Submissions Report

Lot O, 200 Aldington Road, Kemps Creek

SSD-96107226 and SSD-10479-Mod-7

Prepared by Colliers Urban Planning

Design of Lot O as proposed under SSD-10479-MOD 7

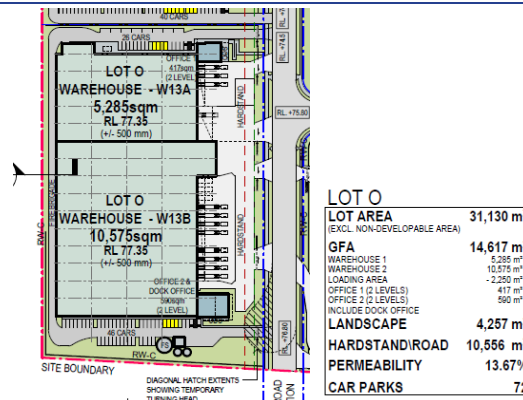
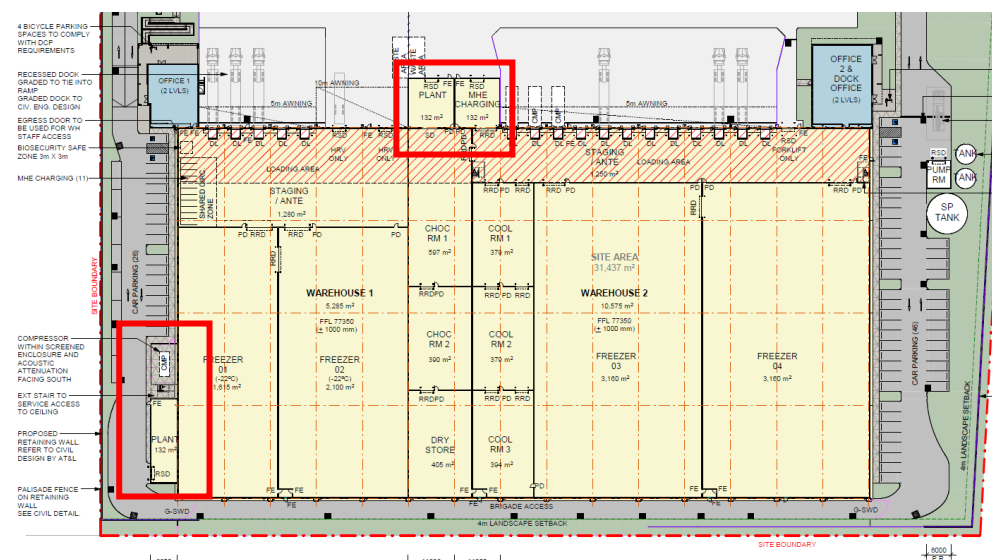
The EIS states that the proposal would reduce the GFA. Please confirm the correct reduction based on the approved GFA and the proposed GFA of 14,617 m ² , and clearly identify where this reduction occurs.	The statement in the EIS is correct. As per the latest approved concept plan (Mod 5), Lot O contained a GFA of 17,270m ² . The proposed Lot O development contains a GFA of 14,617m ² . The change in GFA occurs as a result of changes to the built form and increase eastern boundary setback to accommodate the reconfiguration of the car park.

Figure 1 Extract of Mod 6 Subdivision Plan

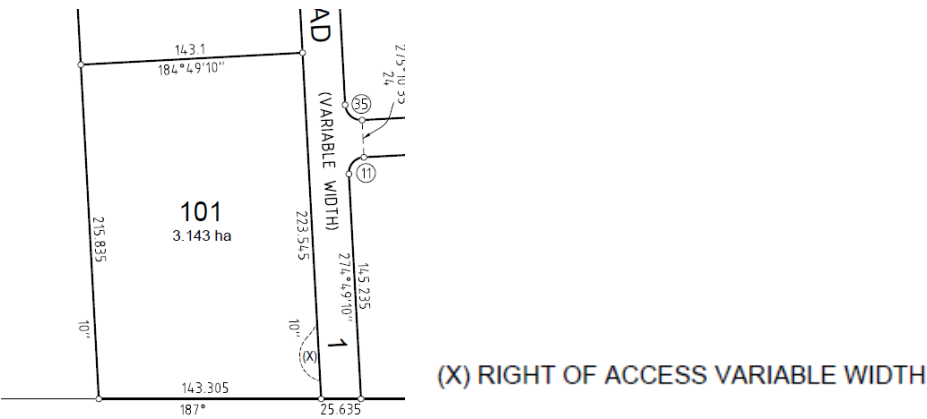
The Department is to consider legal access for the use of the temporary bulb (i.e. right of carriageway).

The Subdivision Plan which accompanied SSD-10479-Mod-6 includes a right of access for the temporary bulb.
